# PERMIT

## SEWAGE DISPOSAL SYSTEM

P 50156  
A 10323  
A REPAIR

6722 MONTELL CT  
TOPOGRAPHIC SURVEY and SITE

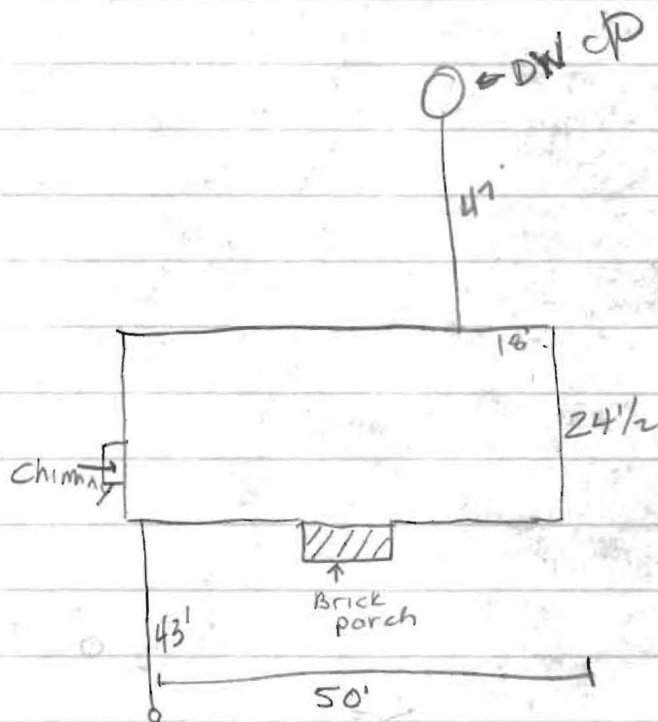
REMARKS: 10/16/94 Test OK to 13' VERY LITTLE LIQUID BUILDUP IN DRYWELL.

OK TO ADD 50' TRENCH w/ 5'-5 1/2" STONE. (CW)

drainpipe is at 7 ft below grade, bottom @ 10 1/2 ft, due to depth of existing drywell, OK  
to put 5 ft gravel (1 ft above pipe). ok to cover when finished - good soils entire length of trench  
Apr 19/97/99

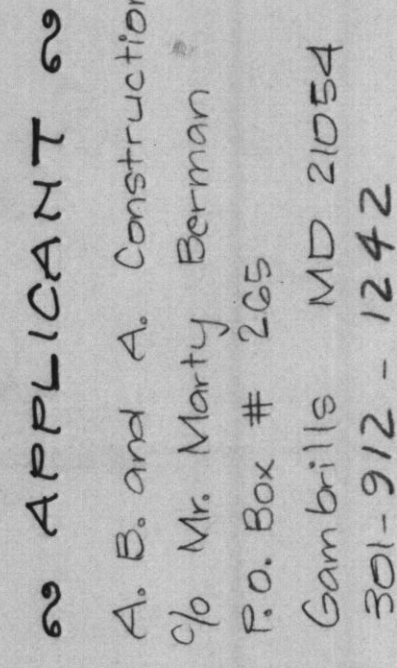
Suggest Repair - System old Adding 1 bedroom
